Project: Land South of Radwinter Road (East of Griffin Place), Saffron Walden

Planning Reference: UTT/21/2509/OP

Technical Note: Outstanding Highways Matters

Project No: CTP-20-1142

SCALE @ A1:	DATE:	DRAWN:	CHECKED:	APPROVED:
1:200	13.05.21	OAS	MP	CE
JOB NO:	DRAWING NO:	REVISION:		
CTP-20-1142	SK10	A

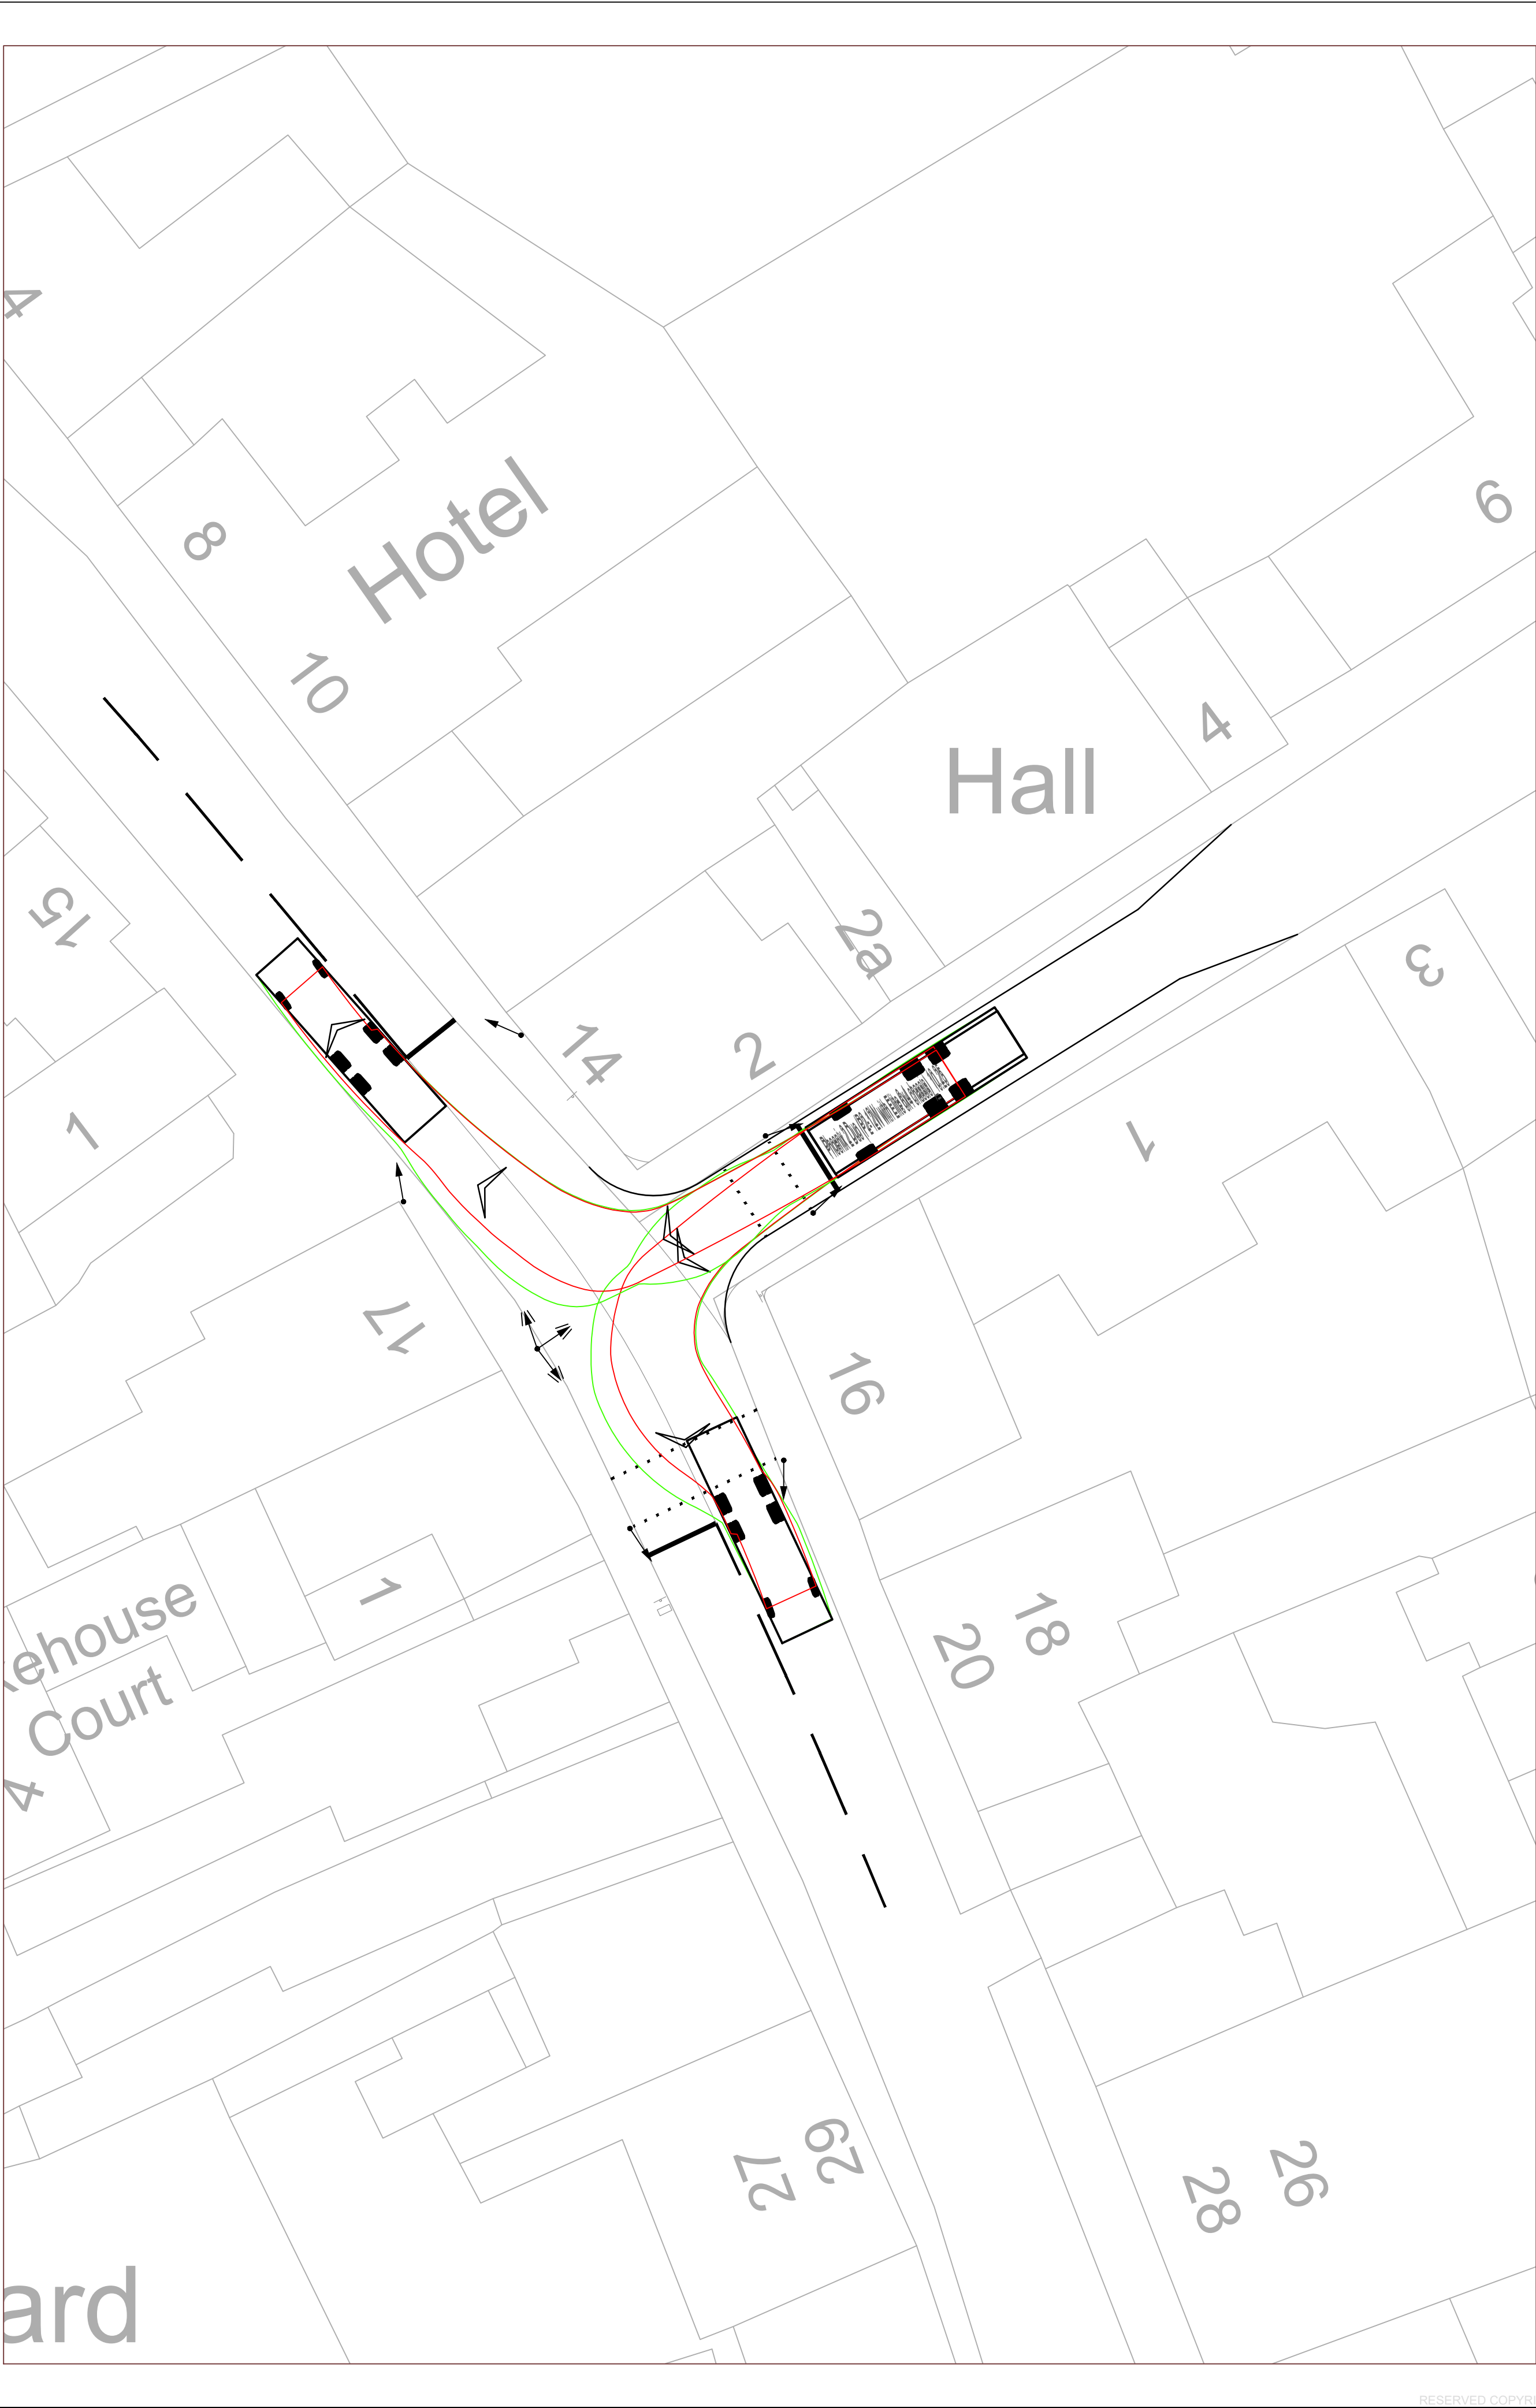
2.46 Referring to Drawing No. CTP-20-1142 SK10 Rev A in Appendix I, it can be seen that the proposed improvements will help to alleviate the issues identified above. The provision of road markings in the centre of the junction will encourage right turning vehicles to wait in a position that improves both the efficiency and safety of the junction.

2.48 The width of the right turn storage areas in the centre of the junction will also enhance the visibility to the opposing through movements between Radwinter Road and East Street. The positioning of the two cars waiting to turn right on the drawing presented in Appendix I, demonstrates that the driver will have an unobstructed view of an oncoming vehicle.
